Access Compliance Report Public Rights-of-Way (Curb Ramps)

Main Street: MARCY_RANCH_RD	Cross Street: MARCY_DR	Location: NW
-----------------------------	------------------------	--------------

ADA ID: RPRK211012174022	Ramp Type: Type 1 - Perpendicular Diagonal Initial Pass/Fail: Fail	Overall Compliance: No	Severity Score: 2
--------------------------	--	------------------------	-------------------

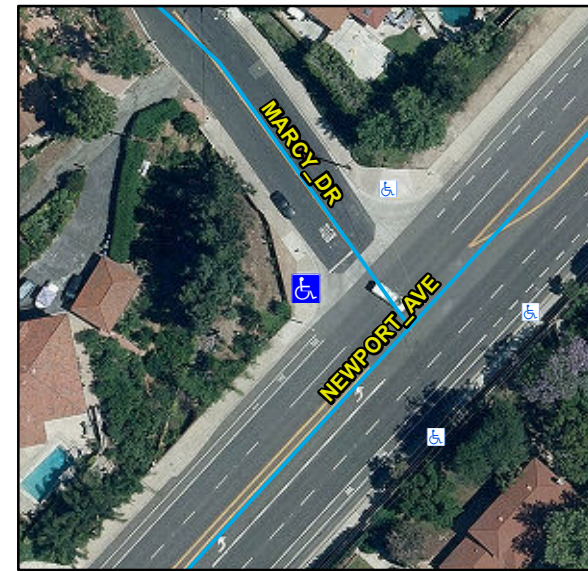
R304.2.2, R204.3, R304.5.3, STD 1115

Remove & Replace Curb Ramp With Two New Directional Ramps or Equivalent.
